In respect of COLLIN LANE, WILLERSEY

Stage 1 Road Safety and Mobility Audit

Project Title:	Collin Lane, Willersey			
Report Title:	Stage 1 Road Safety Aud	it		
Project No:	1511-04	Report No:	RSA1	
Client:	Newland Homes

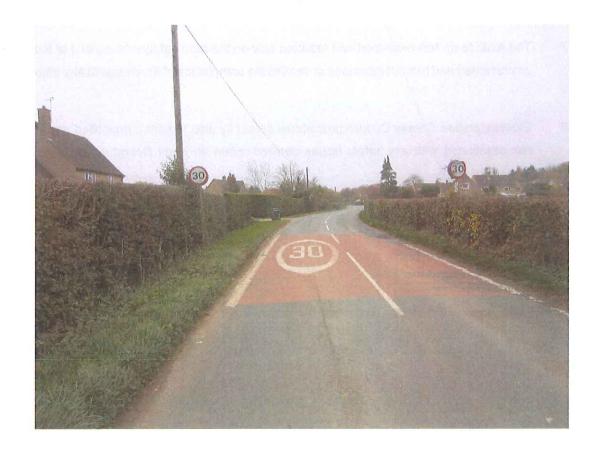
Location: Collin Lane Eastbound approach to the proposed junction.

Summary: There is a 30 mph speed limit approximately 40m from the proposed junction. This limit is at the end of a derestricted speed section. The recorded 85% speeds of 45 mph are considerably in excess of the posted speed limit. Although the visibility splays noted on the drawings are satisfactory for the recorded speeds there remains the risk that vehicles emerging from the site will underestimate these approach speeds with the risk of accidents with turning vehicles.

It is recommended that the site of the 30 mph limit is visually reinforced within the existing verge to provide a village entry point, with appropriate 'Willersey' village signage and gateway features to assist reduction of speeds to within the posted limit.
